MEMO

To: Kristopher Byrd, Well Construction Section Manager
From: Tommy Laird, Well Construction Program Coordinator
Subject: Re-Review of Water Right Application G-19176
Date: December 12, 2022

Groundwater Application Review Summary Form

Application # G- 19176

Well Location Map

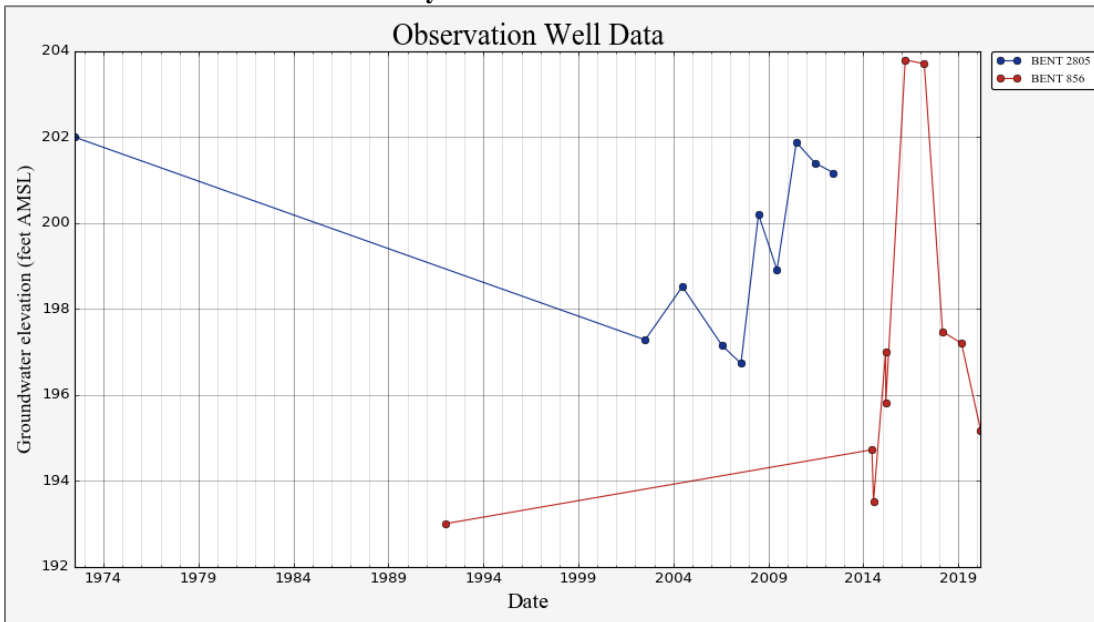
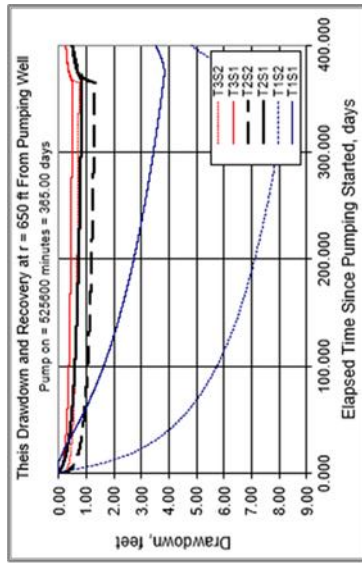
B3. **Groundwater availability remarks:** The aquifer properties in the unconfined Quaternary alluvium here, and the position of the proposed POA well within one mile of the Willamette River make it unlikely that the proposed pumping will induce sufficient drawdown to cause injury to senior water right holders. A Theis time drawdown analysis based on expected local aquifer conditions was performed to evaluate potential impacts to nearby senior groundwater rights. The most reasonable scenarios calculated an anticipated drawdown of less than 5 feet at the nearest mapped point of groundwater appropriation (GR-715; BENT 2669) at a distance of 650 feet after 365 days of continuous pumping at the maximum authorized rate.
